## **NOTICE OF ADDENDUM**

**Addendum No.:** 2

**Procurement No.:** PRC005197

**Procurement Name:** Construction Services for Redevelopment of Comfort Stations at Jack Darling Memorial Park and Huron Park

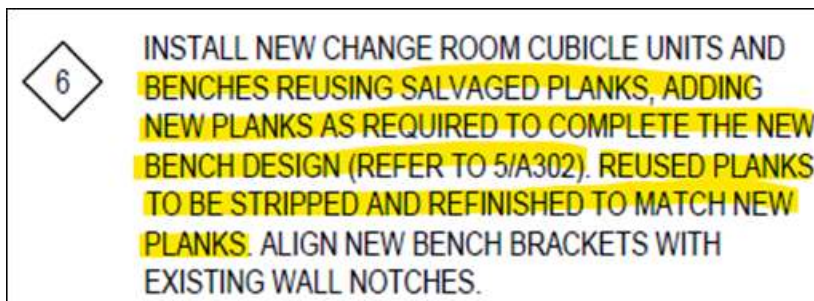
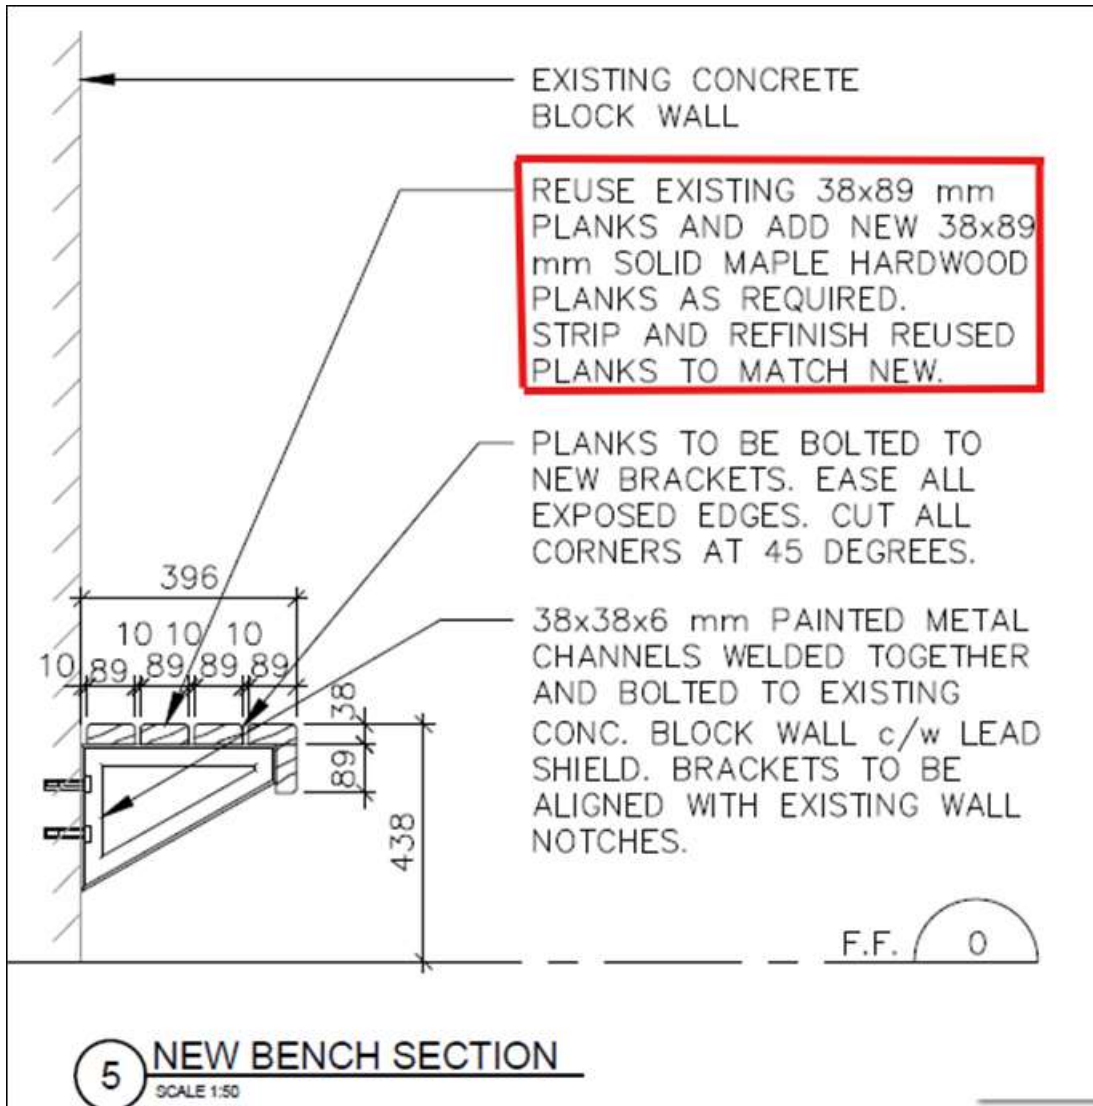
The note on Detail 5 of Drawing A302 for Jack Darling East indicates to “remove all planks, refinish and reuse.” We are seeking clarification on the extent of new wood planks required for the new benches. Should we assume that all existing planks will be reused after refinishing, or will a portion of new planks be required to match or replace damaged material?

As per the following note 5/A302 and new work note No. 6, all existing planks are to be reused after refinishing. However, since the new bench will be wider and include an apron, additional new planks will be required to make up the difference.
